# Sugar Creek Golf Course

Sugar Creek Golf Course is the only golf course owned and operated by the park district. The main issues at this golf course are not having enough accessible parking, slopes being too steep, door force too high, mirrors mounted too high, coat hooks mounted too high, grab bars too high, ball washers not providing clear floor space, and not providing an accessible golf cart. **Please Note:** When a **UD** is indicated, this is a Universal Design (**UD**) recommendation to enhance accessibility. The **UD** recommendation is not required to meet the minimum accessibility standards but it would be encouraged.

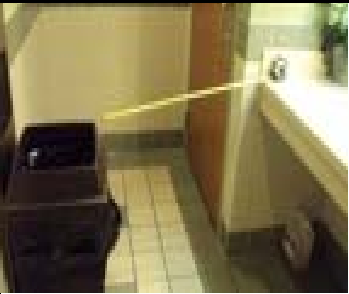
Photo	Barrier	ADAAG/IAC	Solution	Priority	By Whom	Projected Cost	Projected Date	Action Taken
	The walkway from the drop off area to the ramp has a cross slope too steep at 2.6% to 4.1% for 34'.	ADAAG 403.3	Attempt a "mud jacking" technique or remove and regrade section to provide a cross slope no greater than 2%.	<b>1</b>		\$ 2,050.00	2020	
	The mat at the front door is too light and could be a tripping hazard.	ADAAG 302.2	Provide a mat with a heavier backing or tape the mat to the floor.	<b>1</b>		\$ 150.00	2018	Removed mat
	The north door into the clubhouse has an opening force too high at 15 lbs. force and the south door has an opening force too high at 10 lbs. force and closes too quickly at 4 seconds.	IAC 400.310(j)(10)(B)(i)	Adjust the closer so the door opening force is no heavier than 8.5 lbs. to open and takes a minimum of 5 seconds to close or provide an automatic door opener at one of the doors.	<b>1</b>		\$ 100.00	2018	Adjusted door opening force
